Sub: Crescentia and NRK cable laid - MN park premises Pending Works Inspection report - Reg.,

As per joint inspection done with Mr. Satyanarayana (MN Park) dated 25-06-2024, following observations have been noted and need to be attended from our side.

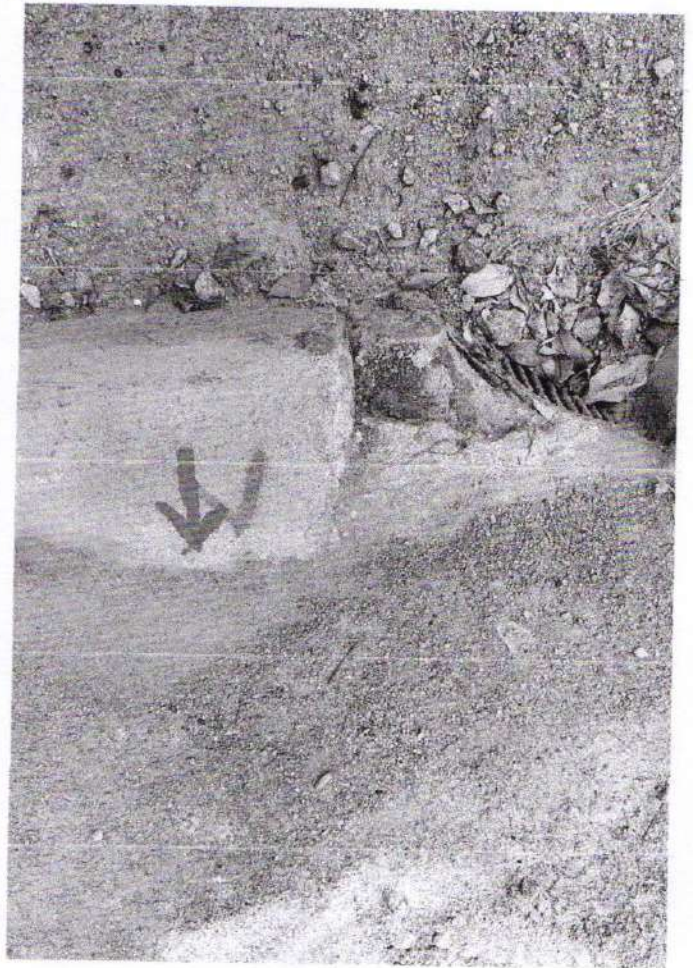
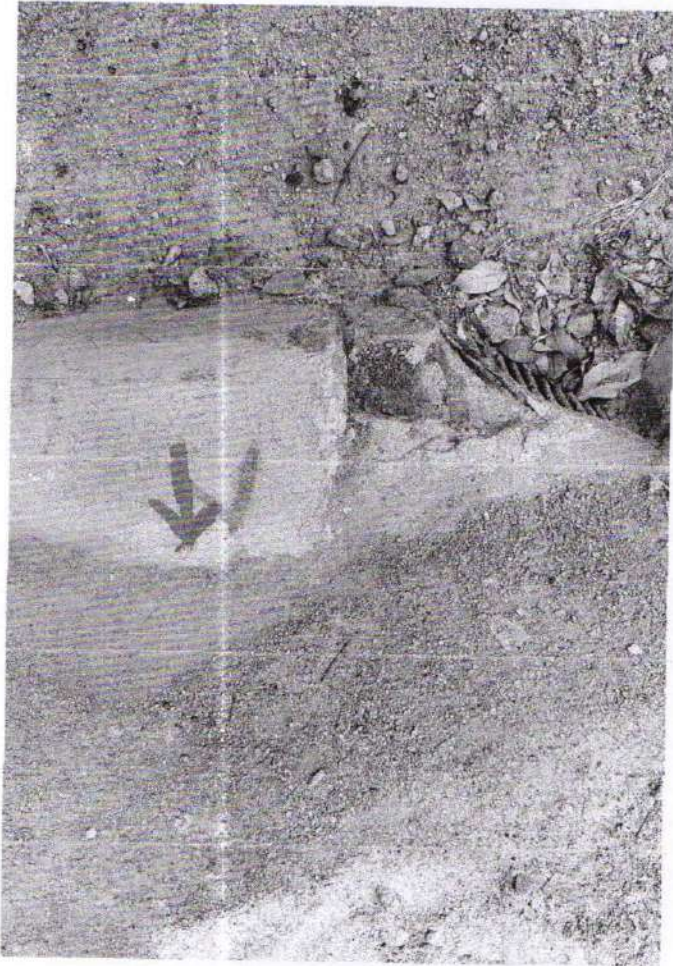
Slotted hole Home pipe damaged

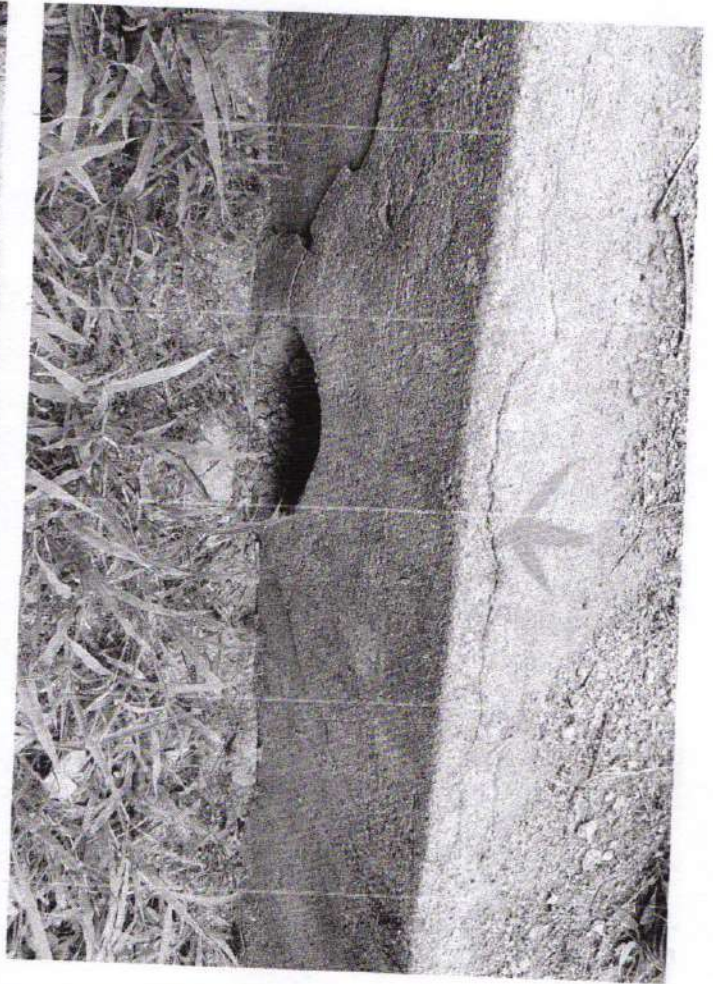
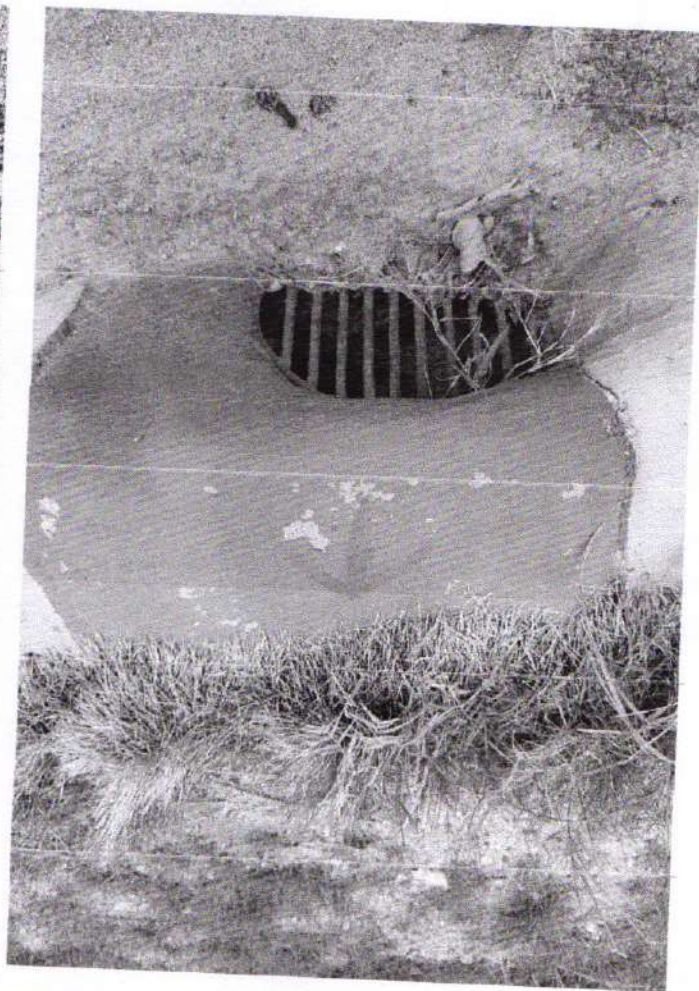
Street light wored not
loose kept on ground
